Access Compliance Report

Public Rights-of-Way

(Curb Ramps)

Intersection ID: 15796	Main Street: SNOW_LN	Cross Street: IDLEWILD_RD_NORTH	Location: SE
ADA ID: D3F4ECD3112C	Ramp Type: PerpDiag	Initial Pass/Fail: Fail	Overall Compliance: No
Severity Score: 22.5			
Codes/Mitigation Info/Possible Solution		Field Measurements/Component Compliance

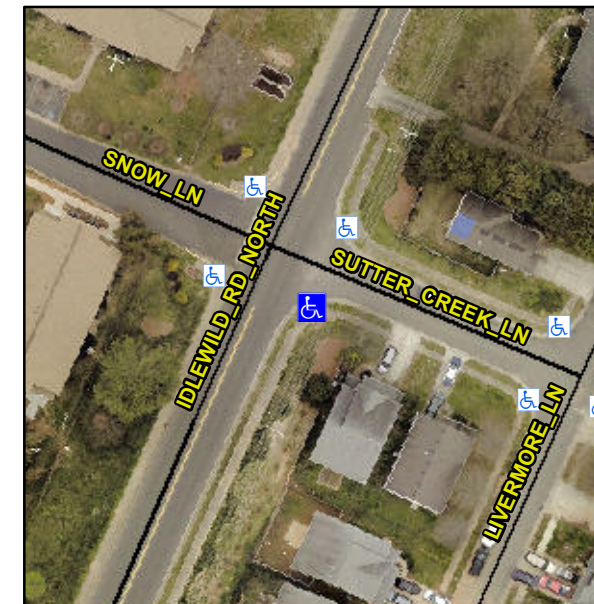
Not Found, R304.5.1, R304.2.2, R304.5.3

Compliance	Description	Data	Compliance	Description	Data
N/A	Ramp Length (in)	52.0	No	Ramp Slope (%)	9.2
No	Ramp Width (in)	38.0	No	Ramp XSlope (%)	3.0
N/A	Flare Type LT	N/A	N/A	Flare Type RT	N/A
N/A	Flare Slope LT (%)	N/A	N/A	Flare Slope RT (%)	N/A
N/A	Flare Traversable LT?	N/A	N/A	Flare Traversable RT?	N/A
N/A	Landing Length (in)	N/A	N/A	DWS Provided?	N/A
N/A	Landing Width (in)	N/A	N/A	DWS Contrast?	N/A
N/A	Landing Slope (%)	N/A	N/A	DWS Length (in)	N/A
N/A	Landing X Slope (%)	N/A	N/A	DWS Full Width?	N/A
N/A	Landing Curb? (Y/N)	N/A	N/A	DWS Offset (in)	N/A
N/A	Shared Landing?	N/A			
N/A	Gutter Ponding?	N/A	N/A	Gutter Slope (%)	N/A
N/A	Gutter Lip Ht (in)	N/A	N/A	Gutter X Slope (%)	N/A
N/A	Painted X Walk1?	No	N/A	Painted X Walk2?	No
	X Walk 1 Direction	To NE		X Walk 2 Direction	To NW
N/A	X Walk 1 Width (in)	N/A	N/A	X Walk 2 Width (in)	N/A
	X Walk 1 Slope (%)	0.8		X Walk 2 Slope (%)	1.8
	X Walk 1 X Slope (%)	1.8		X Walk 2 X Slope (%)	0.8

Remove & Replace Curb Ramp With Two New Directional Ramps or Equivalent.
